**WHITE LAKE TOWNSHIP
INTER-OFFICE MEMORANDUM
COMMUNITY DEVELOPMENT DEPARTMENT**

**SUBJECT: Hypershine Car Wash
Preliminary site plan approval.**
Property described as parcel number 12-23-202-006 (9345 Highland Road), located on the south side of Highland Road, west of Fisk Road, consisting of approximately 4.91 acres.

RE: Hypershine Car Wash- Preliminary Site Plan Review – 2nd Review

RE: Hypershine Auto Wash
Preliminary Site Plan and Special Land Use – Review #2

ACCESSIBLE PARKING STALL MARKINGS
NOT TO SCALE

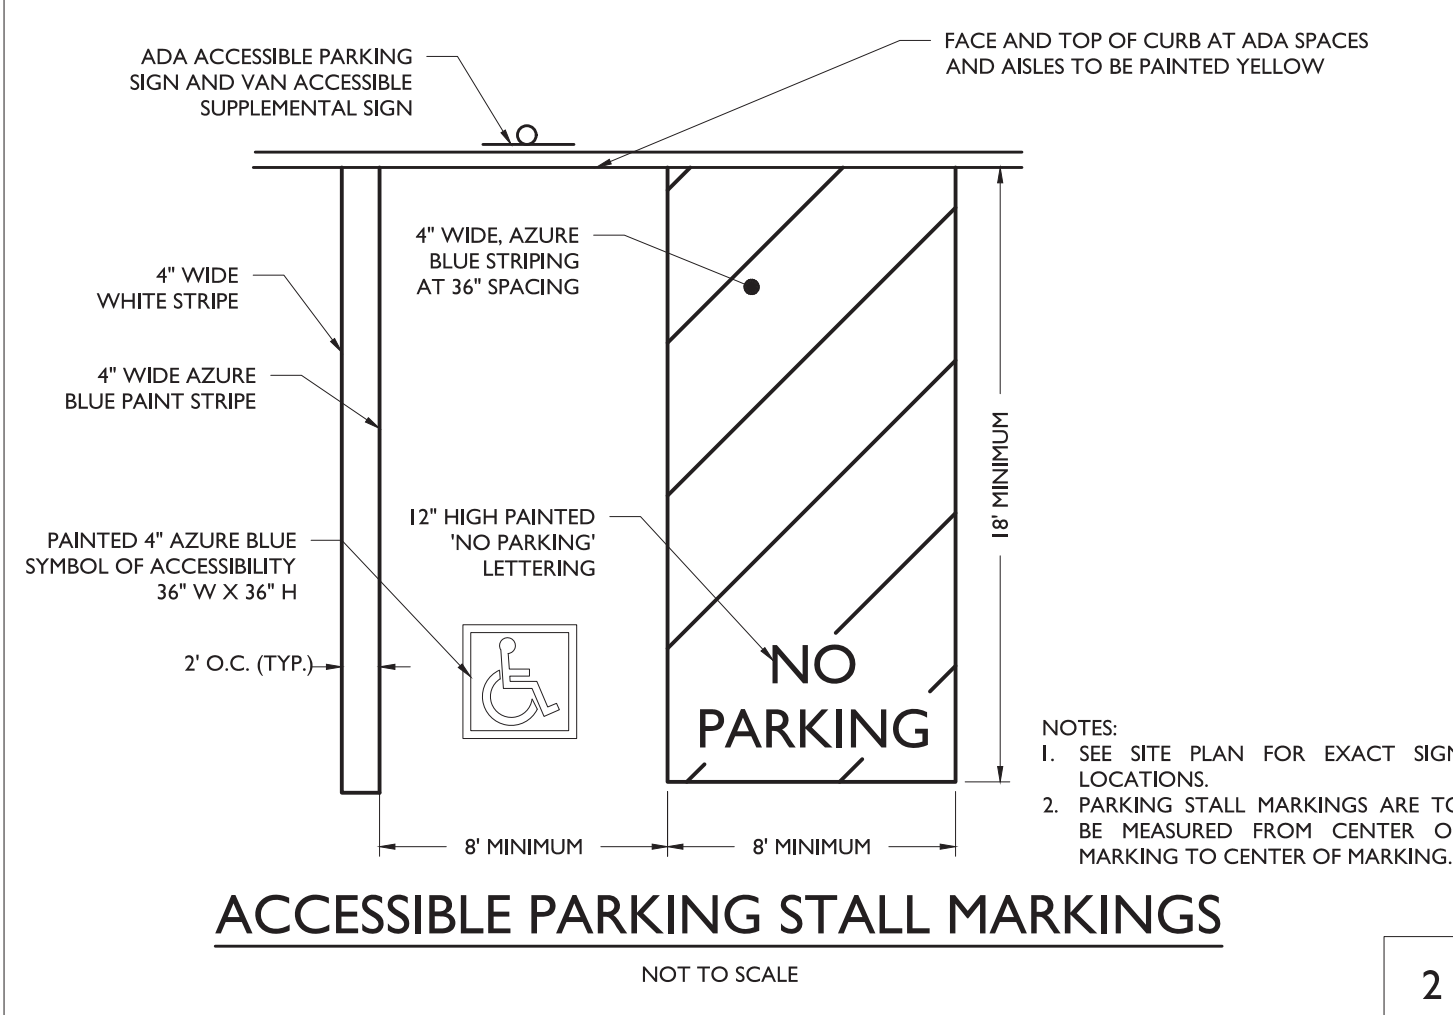
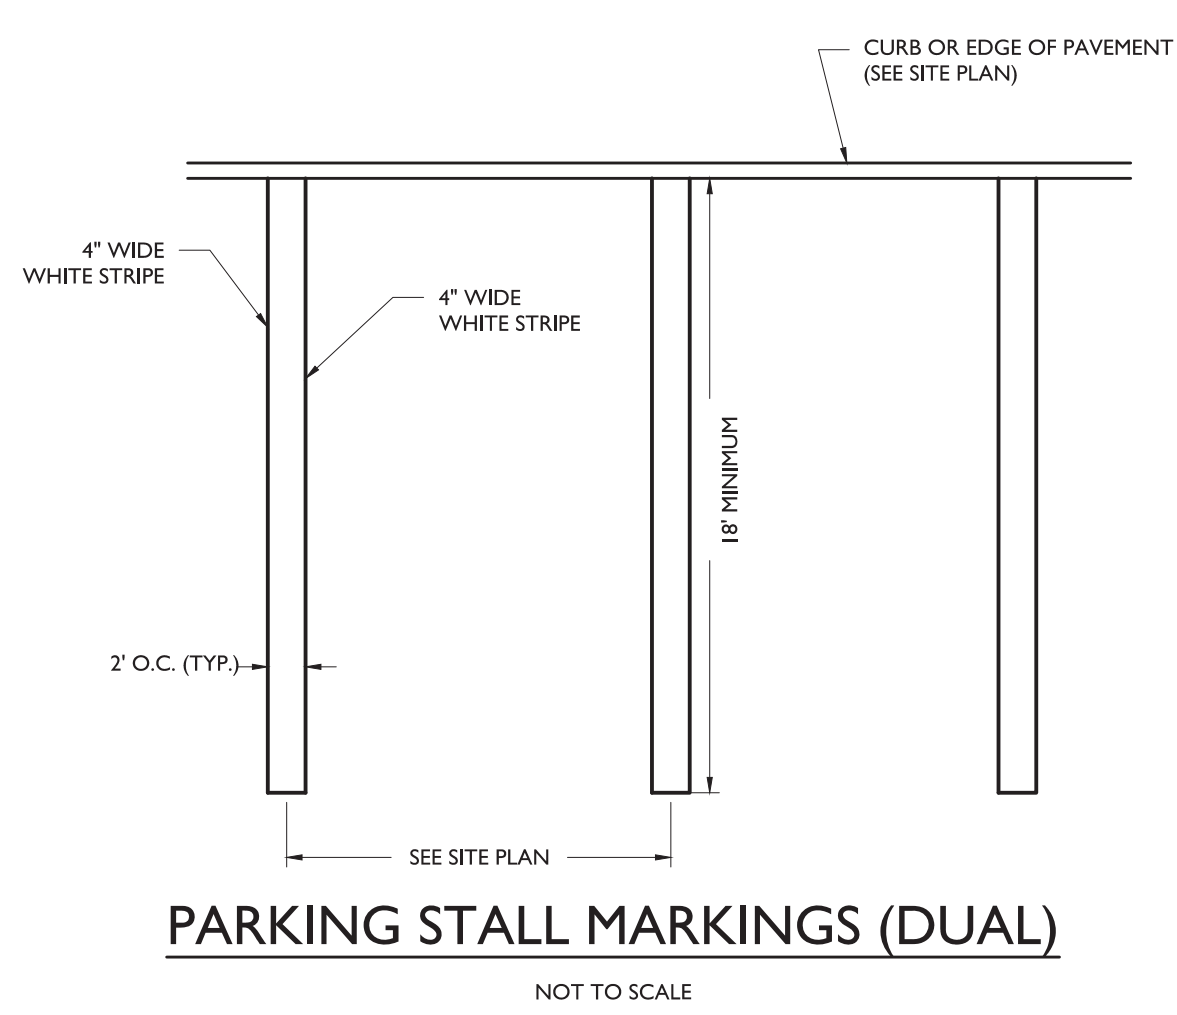
The accessible parking stall detail on Sheet C-8 is inconsistent with the dimensions on the site plan, which shows a three-foot-wide access aisle west of the barrier-free space. In accordance with the zoning ordinance and Americans with Disabilities Act (ADA), the adjacent access aisle shall be eight-feet-wide. The plan shall be revised accordingly. (Comment addressed. ADA accessible space and standard detail has been revised to comply with ADA requirements. **The zoning ordinance also requires each individual parking space be delineated by dual stripes, two feet apart centered on the dividing lines and painted white. The plan (including the parking stall markings detail) shall be revised accordingly to indicate the required striping.** (Comment addressed. Parking stall striping and detail has been revised to provide dual striping).

DRAWING: C-9

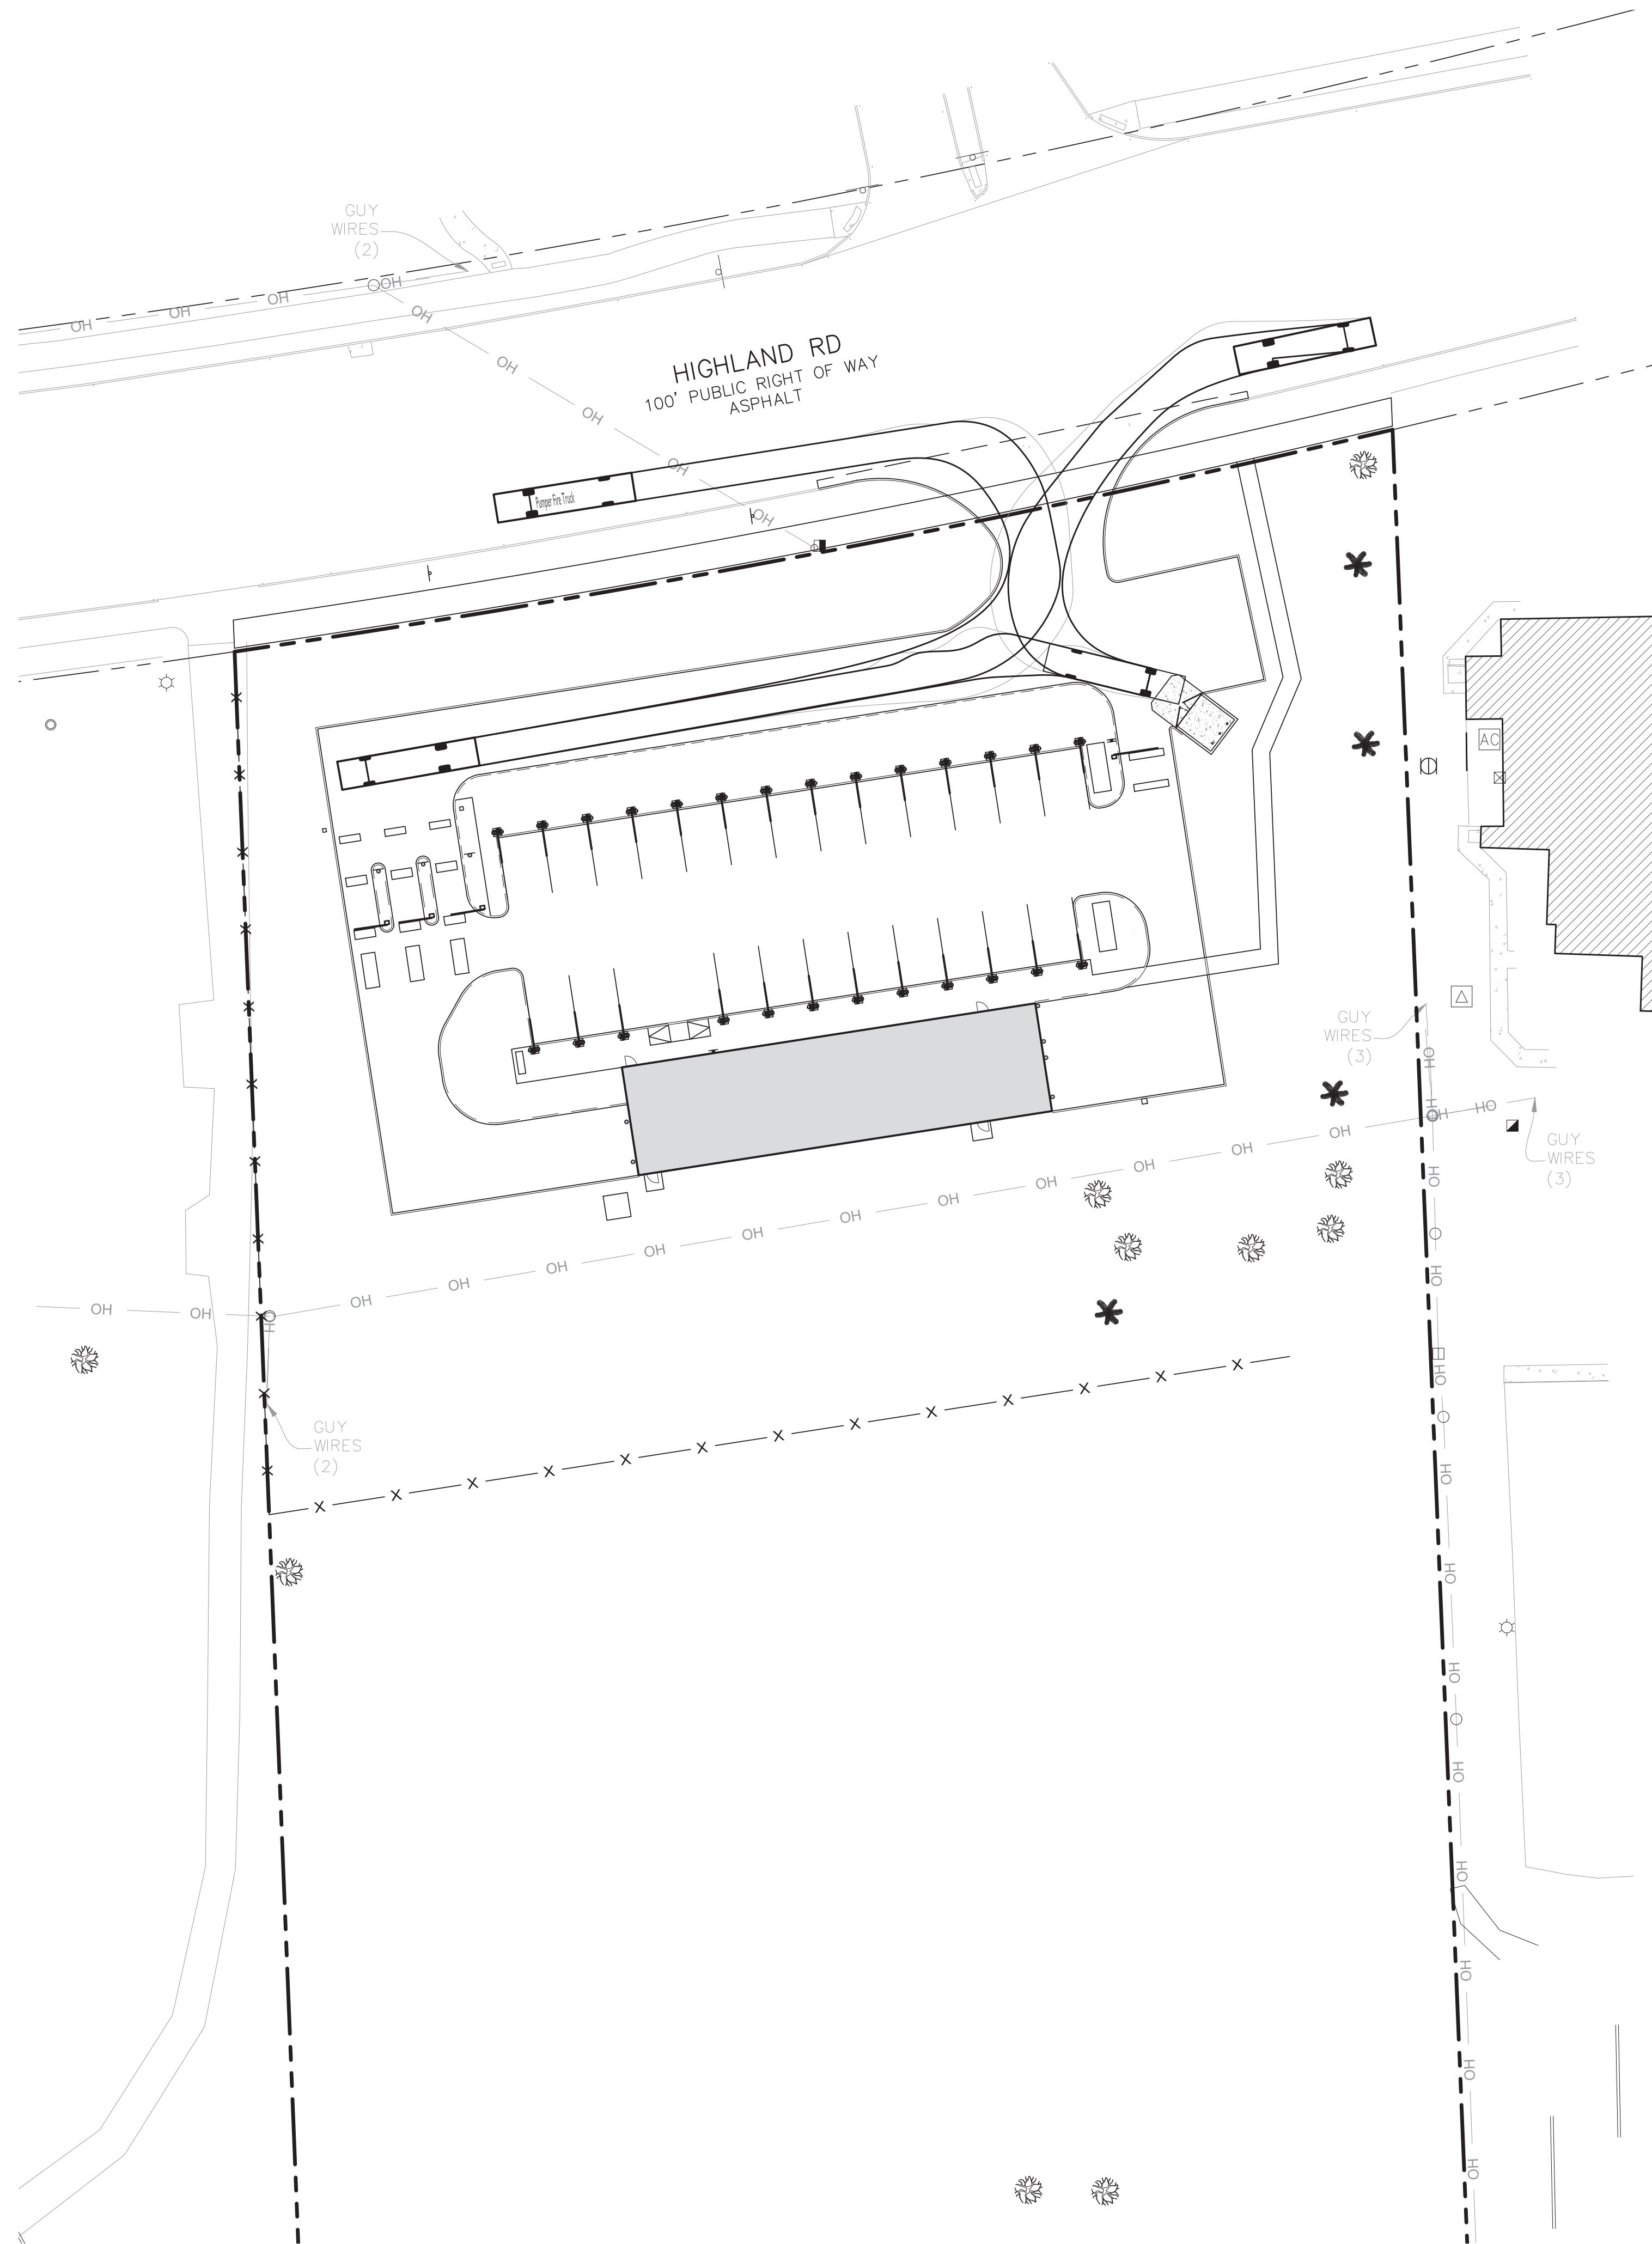
- **The light pole detail indicating height (Sheet C-9) is inconsistent with the height labeled on the lighting plan. Revise accordingly to provide the total height, including the base, pole, and light fixture. (Comment outstanding. Total height shall be measured to the top of the fixture. Additionally, the light pole detail (Sheet C-10 of the revised plans) does not accurately represent the fixture to be utilized on the pole-mounted luminaries. For reference, the fixture is the assembly holding a lamp (bulb). Revise accordingly).**

- **Six-inch straight-faced (vertical) curb of concrete construction shall be used around landscape and parking areas. The standard Michigan Department of Transportation (MDOT) detail for six-inch straight-faced curb shall be provided on Sheet C-9 of the site plan.** (Comment addressed. MDOT standard curb details have been added to Sheet C-9 of the plans).

TITLE:
FIRE TRUCK TURNING EXHIBIT

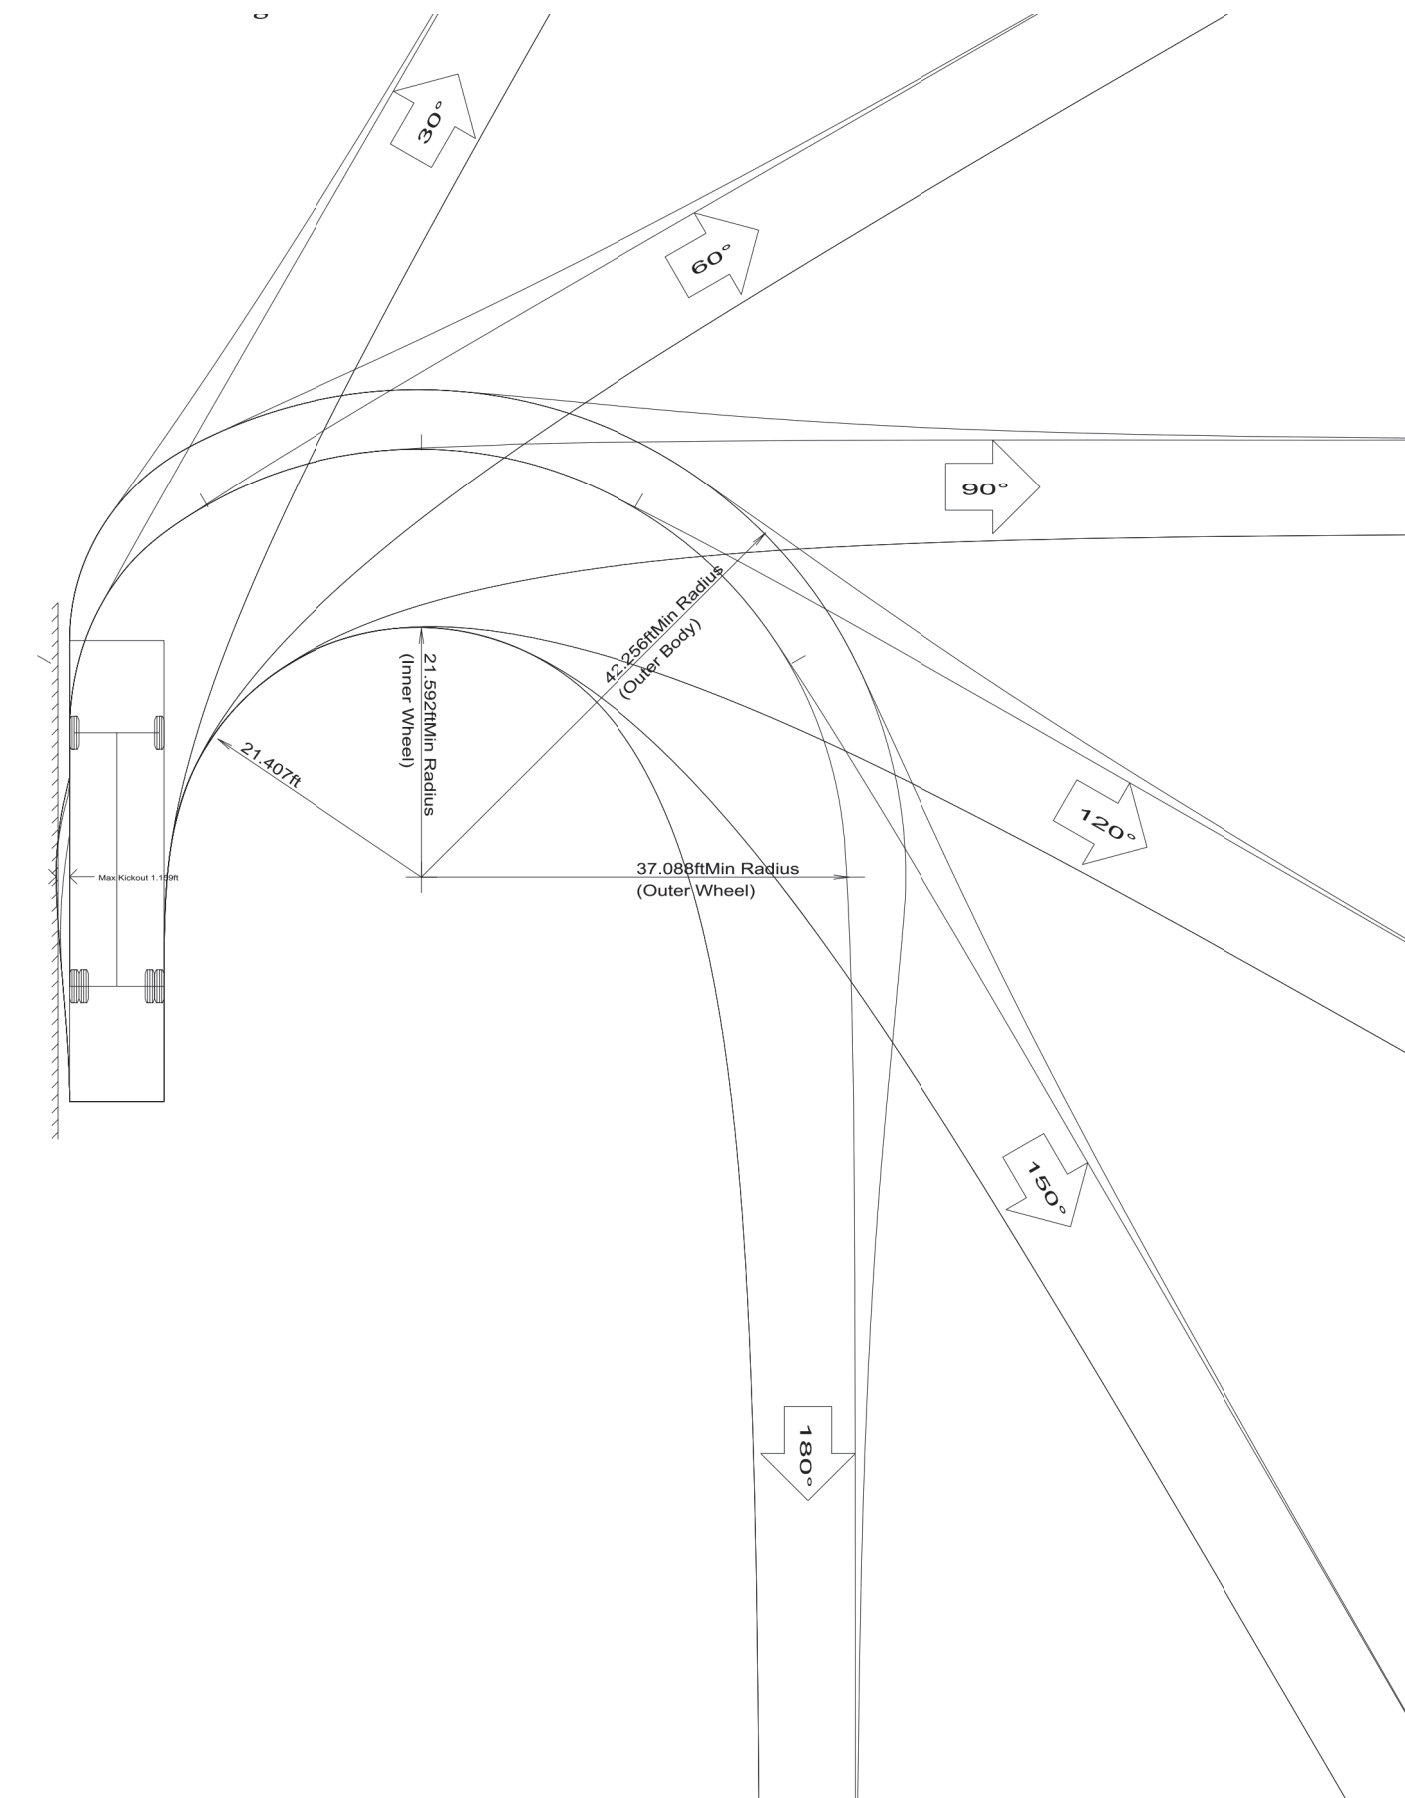
Comment addressed. The existing asphalt walkway shall be removed; an 8' wide path located 1' inside the ROW is now shown.
 - b) *A plan indicating fire truck access and turning radii shall be provided so as to demonstrate fire truck accessibility to the site.* **Comment addressed. A Fire Truck Turning Exhibit plan sheet has now been provided.**

EAST ELEVATION
SCALE: 1/4" = 1'-0"

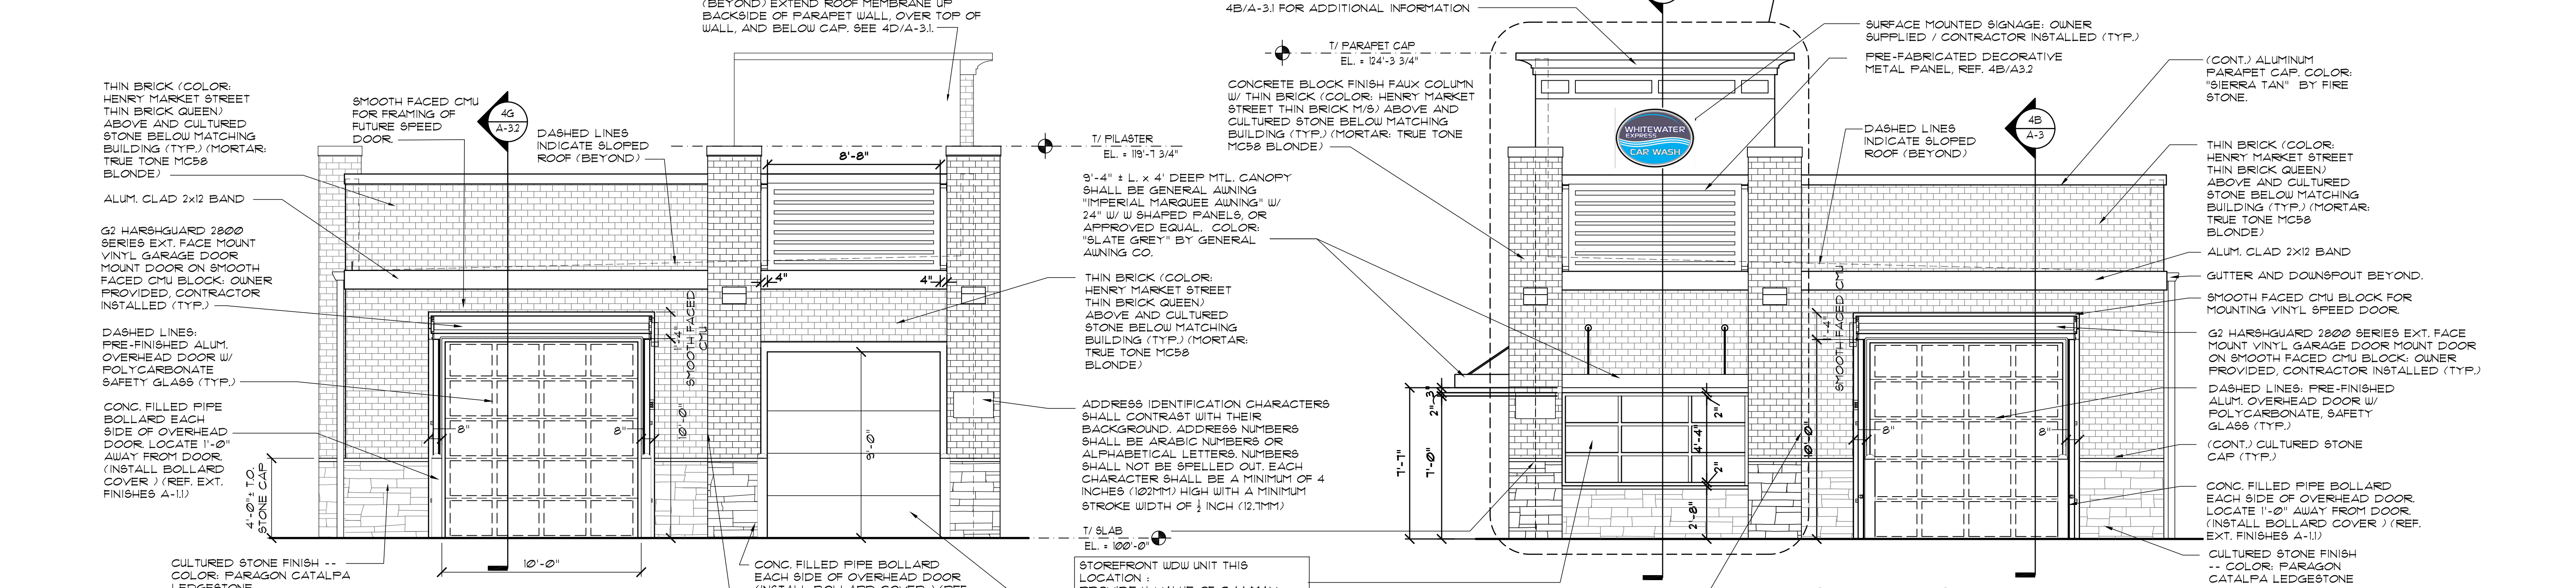
The applicant shall provide an explanation in writing for the purpose of the second overhead door (north door) on the east elevation of the building. (Comment partially addressed. The applicant's engineer stated the second overhead door at the exit is to be utilized for chemical deliveries and maintenance access to mechanical equipment. Sheet A-1 (floor plan) shows equipment locations. Sheet A-1 shall be revised; it incorrectly identifies the east elevation of the building as the car wash entrance and the west elevation of the building as the car wash exit. Those labels (and directorial arrows) are reversed and shall be revised at the time of final site plan).
